## Improvement Permit

## Harnett County Department of Public Health Site Sketch

RE: Truck Tire Pro

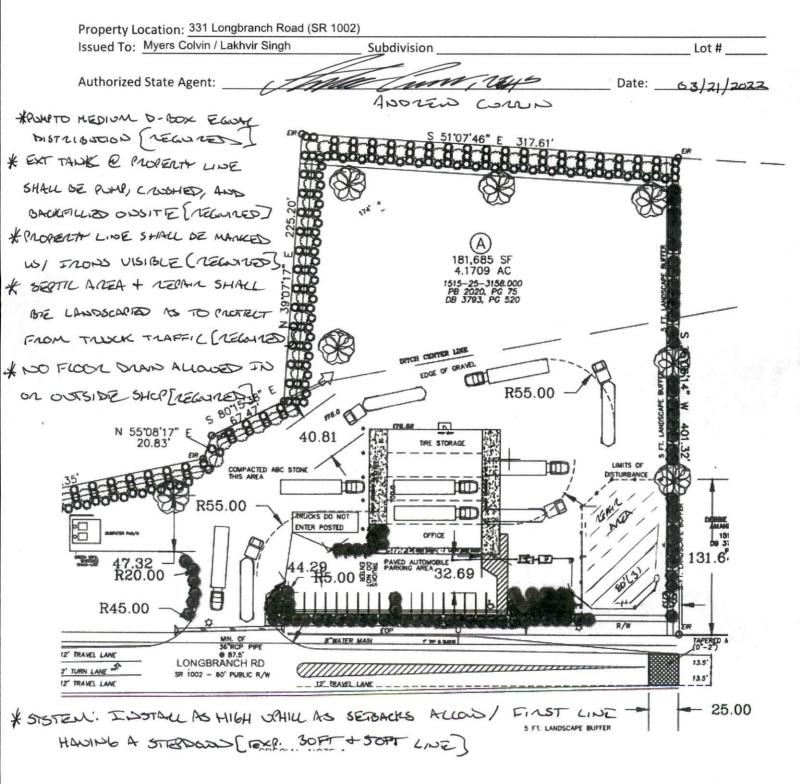
\* BASED ON PLUMDING, GLADE, AND SITE CONSIDERATIONS TRAFFIC NATED TANKS WILL LIKELY
BE REGULATED W/ TRAFFIC RATED RISERS ACCESS. TRAFFIC RATES TANKS WILL BE
REGULATED IF DEEDER THAN 36IN OR IF SUBJECT TO TRAFFIC FLOW

- Property lines are no longer clearly marked. It appears the farmer or clearing team plowed through the line and iron along right side. Please clearly mark the right property line with the front (present) and rear iron (not visible) clearly visible at install to verify setbacks (10ft)
- Proposed septic area shall not be subject to traffic or grading. Advised to include landscaping or curbing to prevent any potential traffic.
- Septic area shall be clearly protected via fencing, roping, landscaping, etc. prior to approval and machinery approved on property. Please protect the designed septic area as desired.
- Based on plumbing, grade, and site considerations traffic rated tanks will likely be required with traffic rated riser access. Traffic rated tanks will be required if deeper than 36in or subject to traffic flow.

- No floor drains are allowed in the shop or outside the shop. An engineered system would be required if so. Please confirm that no floor drains or external drains will be in the shop.

Keep in mind that the designed septic area is the only area on the property suitable for a septic system. If the septic area is graded, altered, or damaged the project will have to be abandoned. It is the best interest of the potential business owner to ensure this area and future septic system are protected to the best of their ability.

I have read and concurr that the noted stipulations for permitting shall be implemented and provided accordingly by the project owner.
